City of Portland, Maine – Building or Use Permit Application 389 Congress Street, 04101, Tel: (207) 874-8703, FAX: 874-8716

Location of Construction: 32 Rosedale Street		Owner: Thomas Roche		Phone: 797-9045		Permit No: 981449	
Owner Address:		Lessee/Buyer's Name:		Phone:		BusinessName:	
Contractor Name: **Peter B. Rice		Address: 94 Webster Rd. Freeport, ME 04032		Phone: 865-4061		Permit Issued: DEC 28 1998	
Past Use: 1-Family		Proposed Use: Same		COST OF WORK: \$ 20,000		PERMIT FEE: \$ 120.00	
Proposed Project Description: Interior renovations. Replace existing cabinets & 2 bathroom fixtures.				FIRE DEPT. <input type="checkbox"/> Approved <input type="checkbox"/> Denied		INSPECTION: Use Group: B3 Type: 5B BOCA 96	
				Signature:		Signature: <i>[Signature]</i>	
PEDESTRIAN ACTIVITIES DISTRICT (P.A.D.)				Action: Approved <input type="checkbox"/>		Zoning Approval: <i>OK</i>	
				Approved with Conditions: <input type="checkbox"/>		Special Zone of Reviews:	
Permit Taken By: <i>ub</i>				Date Applied For: 12/21/98 12/21/98		<input type="checkbox"/> Shoreland <input type="checkbox"/> Wetland <input type="checkbox"/> Flood Zone <input type="checkbox"/> Subdivision <input type="checkbox"/

Proposed Changes

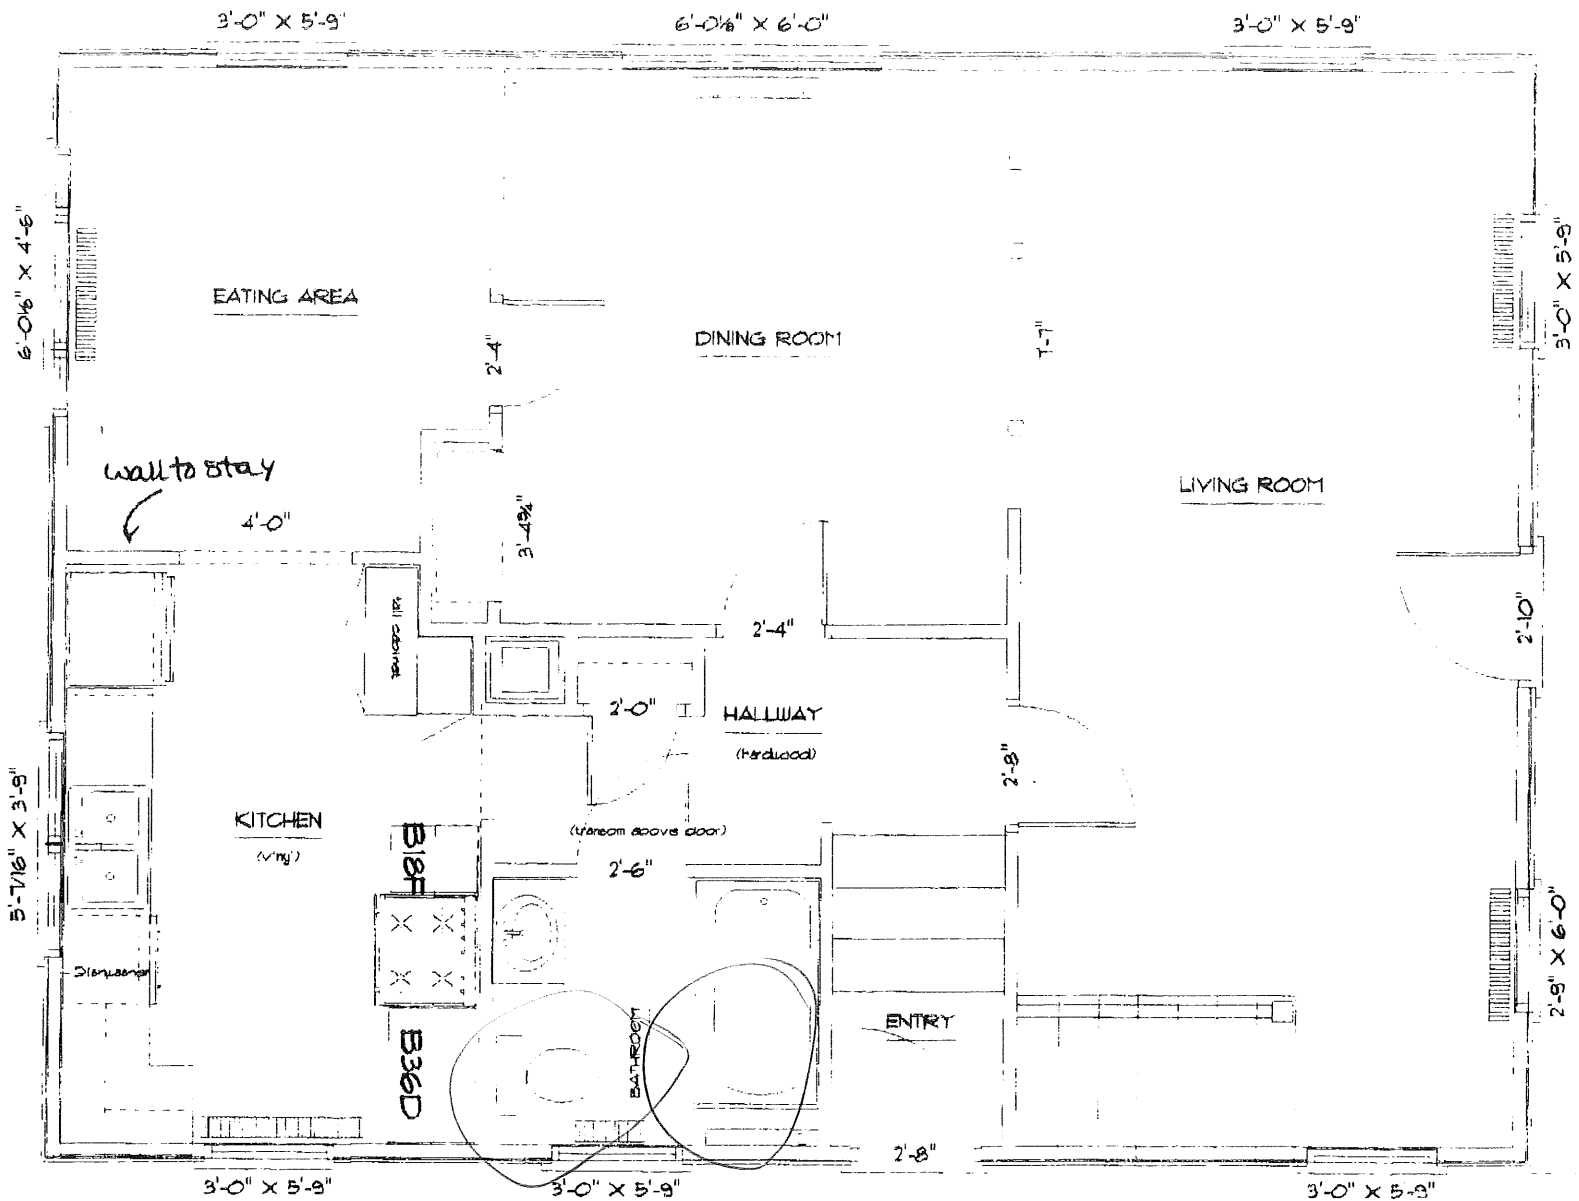
1/5/99 - Did insp of framing - appears ok - need to add header over window in kitchen. J.M.
